Background: The Fort DuPont redevelopment and Preservation Corporation submitted an application to DNREC to install slope stabilization revetment along the eastern bank of the Delaware City Branch Channel to the Chesapeake and Delaware Canal. DNREC published a public notice in September 2020 and held a virtual Public Hearing in January 2021. This letter supports and expands on my October 2020 Public Notice comments.

## ENGINEER DRAWINGS (SCALED PLAN VIEW)

**Figure 1. (above) Highlighted in the upper left-hand corner of the figure is the Parcel Tax ID Number reported by the Fort Corp on line 9, the work site. That parcel is circled on the map in red on the 6(f) parcel between Wingate Road and the river. Also shown in blue are the zoning boundaries.**

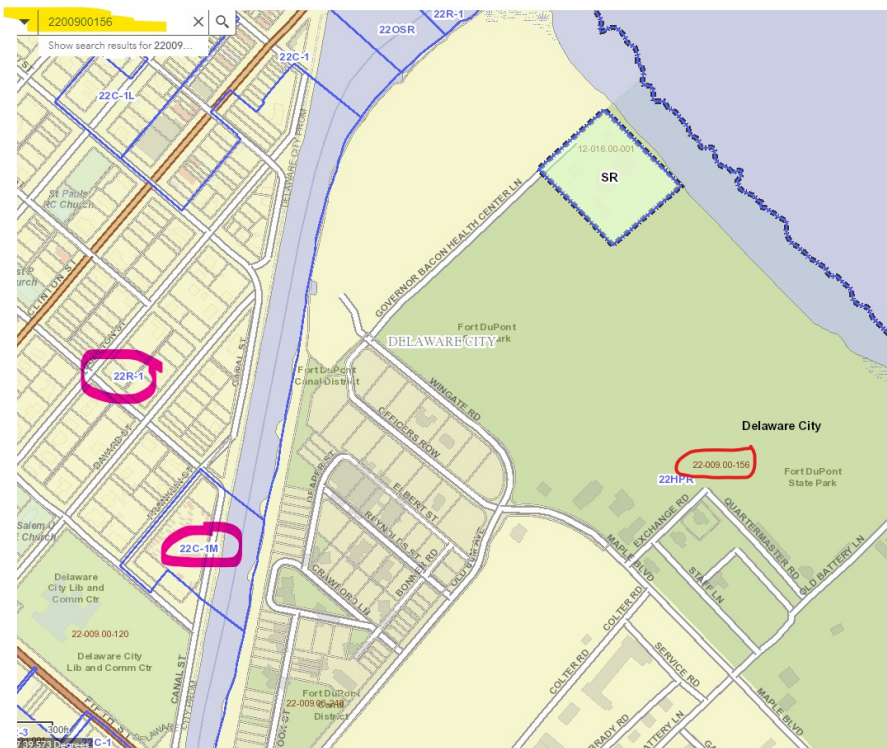
Line 9 misrepresents the Tax Parcel ID Number of the project location. The applicant used a Tax Parcel ID not associated with the work site. The Tax Parcel supplied by the applicant between Wingate Road and the Delaware River. The Tax Parcel supplied has no association or proximity to the work site. Therefore, the applicant and agent knew or should have known that the Tax Parcel provided on Line 9 was false at the time the application was signed and certified as true and accurate by both parties.

**Figure 4. Slide #4 from Applicant’s Public Hearing Presentation which incorrectly refers to the Chesapeake and Delaware Branch Channel**

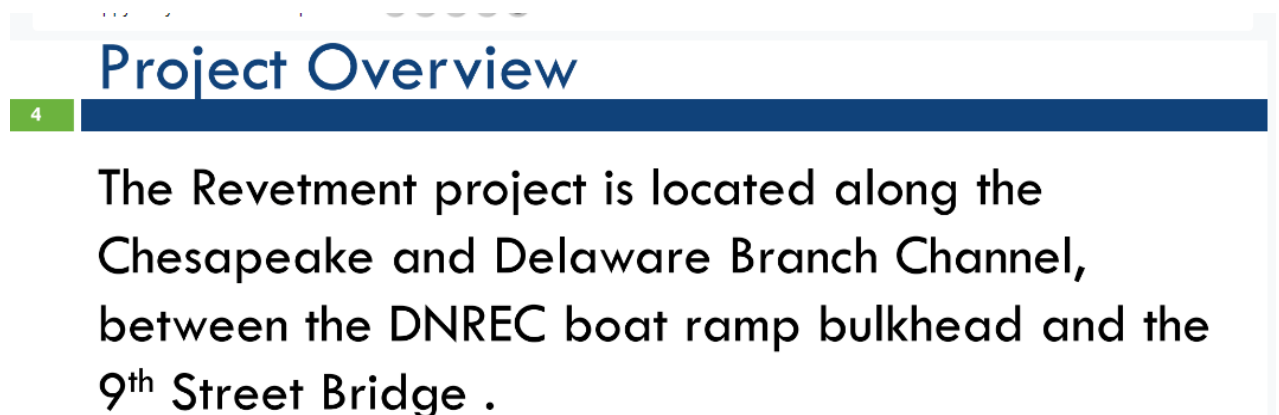
Slide #4 (next page) of the Applicant’s Public Hearing Presentation refers to the work site as the Chesapeake and Delaware Branch Channel. The worksite is the Delaware City Branch Channel as previously stated. There is no Chesapeake and Delaware Branch Channel in or near Delaware City. However, the slide places the southern boundary of the work site as the “9th Street Bridge”. There is no 9<sup>th</sup> Street Bridge at the work site or in Delaware City. There is one bridge that crosses the Delaware City Branch Channel. In the past the bridge crossing the DC Channel was referred to as the 5<sup>th</sup> Street Bridge but was recently dedicated as the Michelle Smith Memorial Bridge.

**Figure 5. Slide 7 (above) from the Applicant's Public Hearing Presentation**

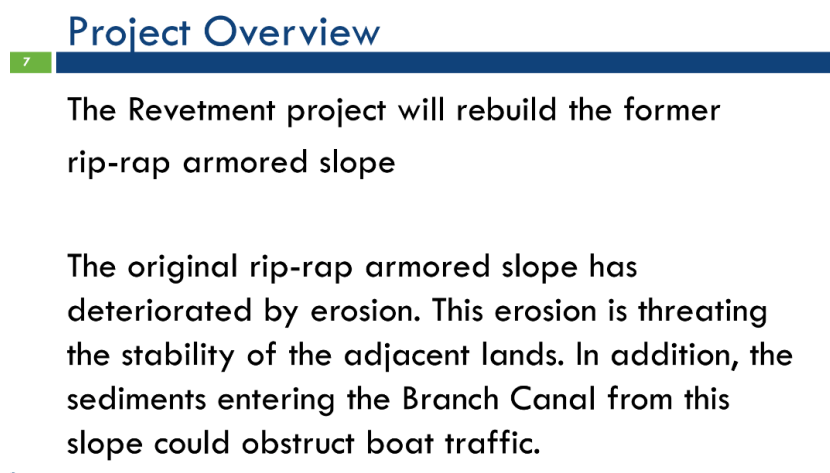
Neither the Basic Application nor Appendix I admit to the prior structures at the work site. The Basic Application and Appendix state that the proposed construction is new, that it does not replace any previous structures. Yet the Applicant's Public Hearing Presentation acknowledges that previous structures exist at the work site on the Delaware City Branch Channel.

**Figure 6. Line 4 from the Permit Application, No indication of "Repair/Replacement"**

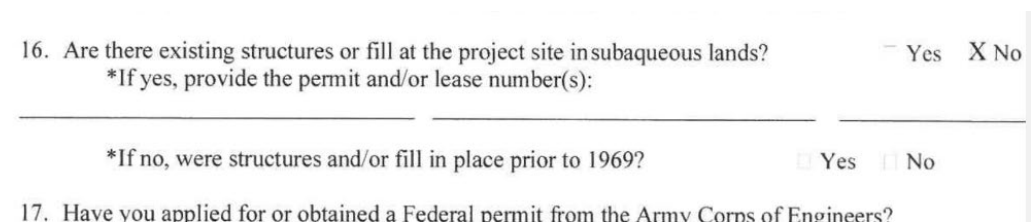
Line 4. The applicant indicates that this project is not a replacement of any previous project but is a new project. The fact that the project is replacing the last surviving, intact remnants of the original nearly 200-year old Chesapeake and Delaware Canal is not acknowledged on Line 4. The application, appendix and public hearing presentation are all silent to the point that the work site is of national historic importance. It is made more odd because the Fort Corp has in its name "Preservation" and files its corporate taxes using a NAICS Code for a historical site. It is far simpler for the applicant to omit the historical reference to avoid mandatorily answering Line 16 in the Basic Application. Line 16 requests information about the previous structures and explicitly requests to know if the structures pre-date 1969. However, the Applicant's Public Hearing Presentation refers to the previous, existing slope stabilization project in Slide 7:

Posted below are the two lines snipped from the Basic Application that falsely deny the presence of previous structures at the work site. Slide's 7 bullet points are incongruent with the statements that are certified as true and accurate in the Basic Application.

**Figure 8. Slide #12 from the Permit Application, Similar Revetment West Bank**

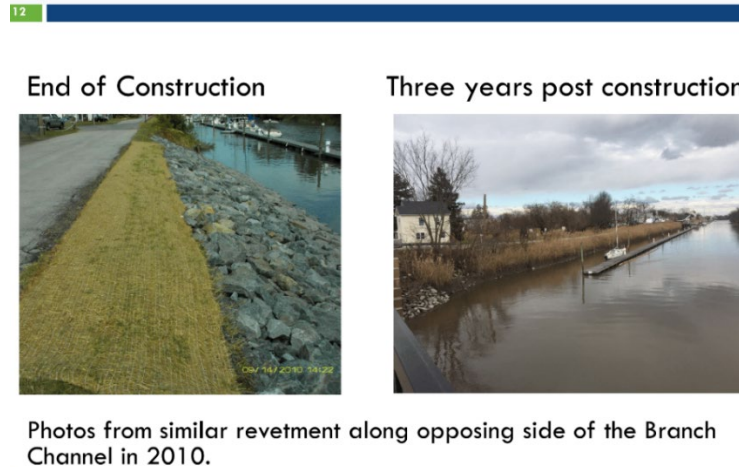
The applicant showed Slide #12 (previous page) and made comments to the effect:

1. both revetments were similar and
2. the photo on the right showed vegetative growth after three years

Both statements are incorrect.

The photo of phragmites invasion on the right hand side of Slide #12 is labeled "Three Years Post Construction. The photo was taken in either the last week of December 2020 or the first two weeks of January 2021 and not in 2013 as suggested by the slide's

**Figure 9. Slide #11 from Applicant's Public Hearing Presentation, Cross-Section of Design**

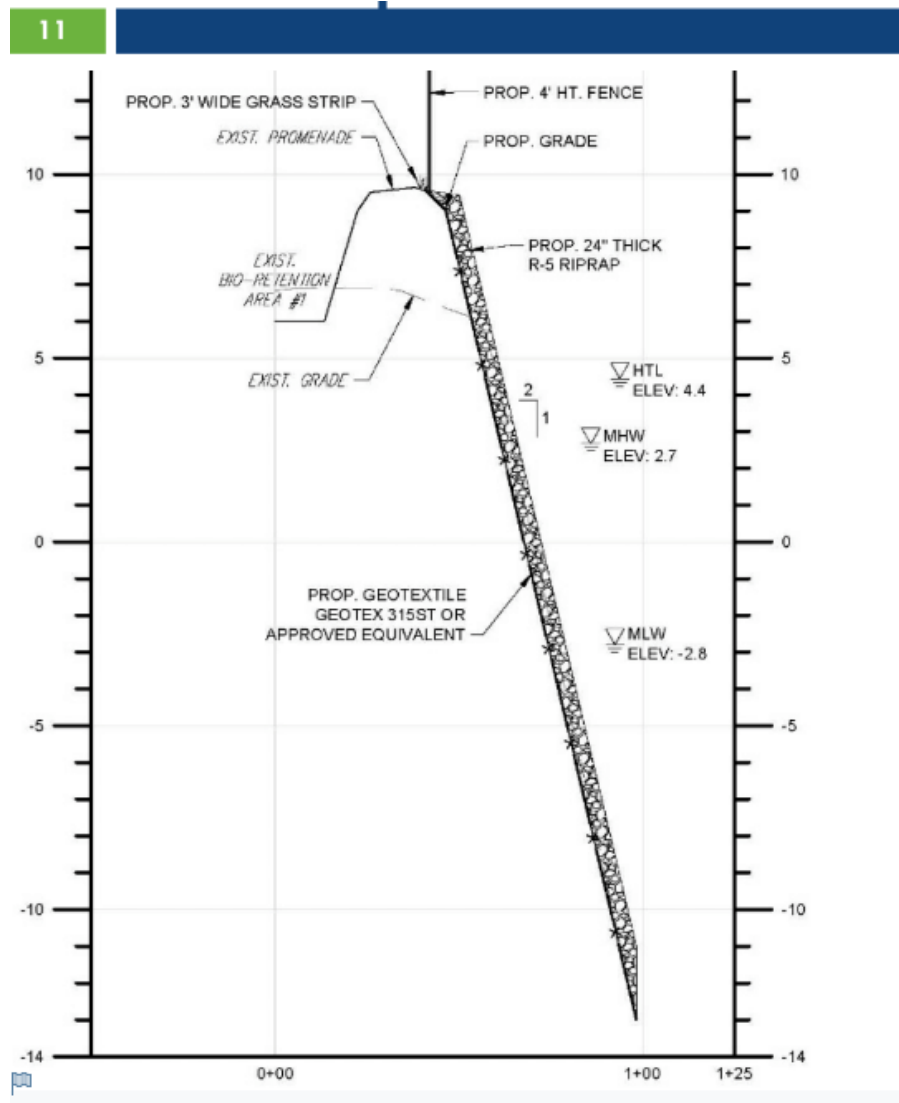
Slide #11 shows a cross-section of the revetment with an exaggerated vertical scale. It shows a simple rip-rap revetment with a vertical height of 22.5 feet (from bottom to top) and a 2:1 slope armored with 24" of R-5 rip-rap placed on a geotextile material. There is no anchor trench. There is no toe anchor shown in Slide #11.

**Figure 10. Cross-section Detail by Duffield Associates of west bank slope stabilization revetment**

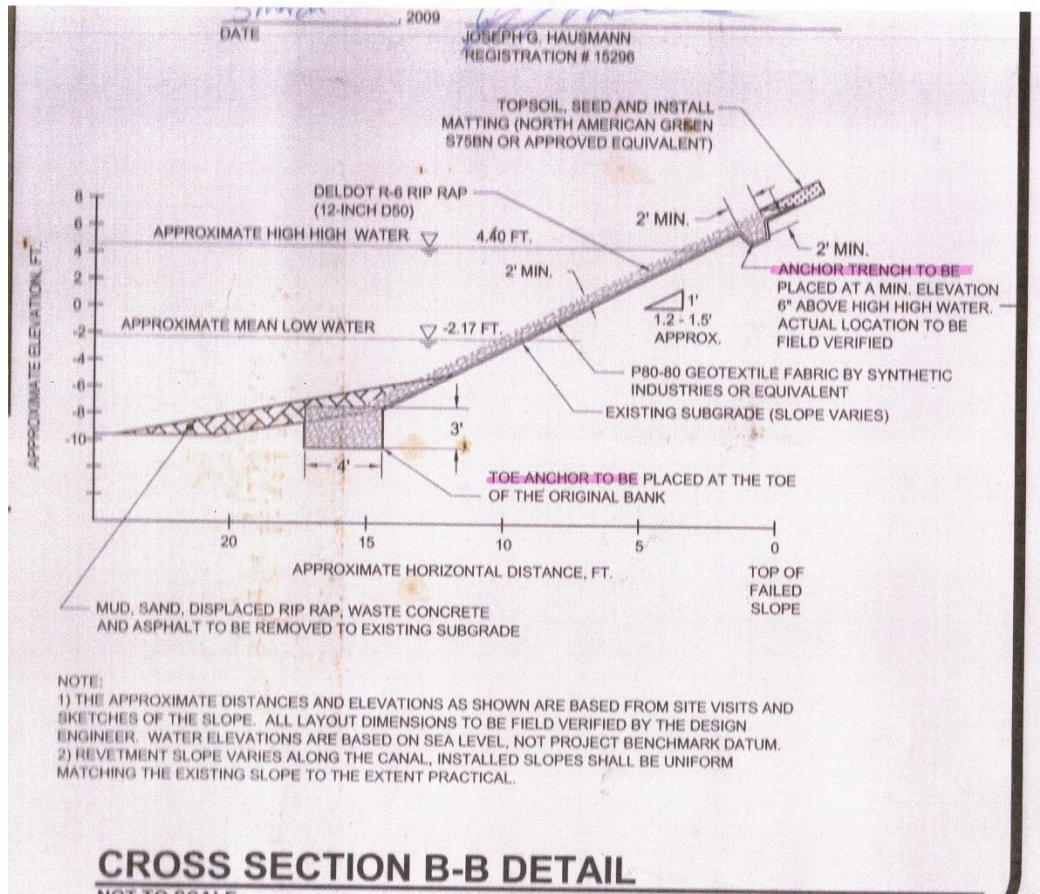
The design shown above has structural components not used in the Fort DuPont Revetment design. Notice the use of an anchor trench at the top of the revetment. The filter cloth is placed in the entire length of the anchor trench and in the back, bottom and front of the 24" trench which allows an extra 2 feet of overburden rip-rap on the geotextile to hold it in place. The slope design is 1.2:1 or 1.5:1 and not 2:1 as the Fort DuPont design. An anchor toe 4'x3' is placed at the bottom of the slope to reduce the effects of scour and ice movement of the rip-rap. None of these design features occur in the Fort DuPont revetment design.
